# Technical Service Information

## FORD ATX DELAYED OR NO 1-2 SHIFT

Figure 1

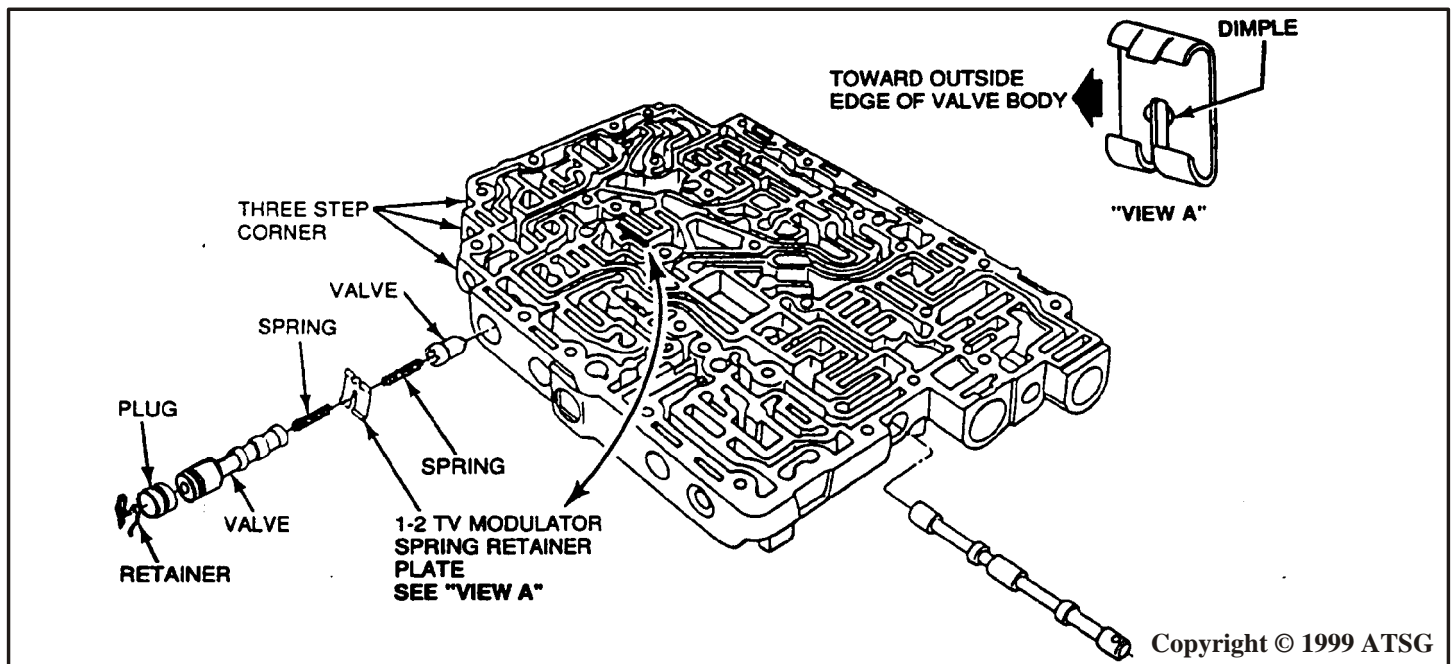
**COMPLAINT:** Some 1987-1990 Escort, Taurus, and some 1987-1993 Tempo vehicles may exhibit an intermittent or no 1-2 upshift, or a delayed (Higher Than Normal) 1-2 upshift. This condition usually occurs during the initial drive away after extended or overnight parking, and may correct itself and perform normally after warming up.

**CAUSE:** The cause may be the TV modulator spring turning around in the 1-2 shift bore in the valve body.

**CORRECTION:** Install a new design TV modulator spring retainer plate, OEM number F23Z-7F194-A, which has a "Dimple" on the retainer to prevent the spring from turning around in the bore. The dimple goes toward the outside edge of valve body, and the proper location are both shown in Figure 1. The dimple will now keep the spring centered in the valve body bore.
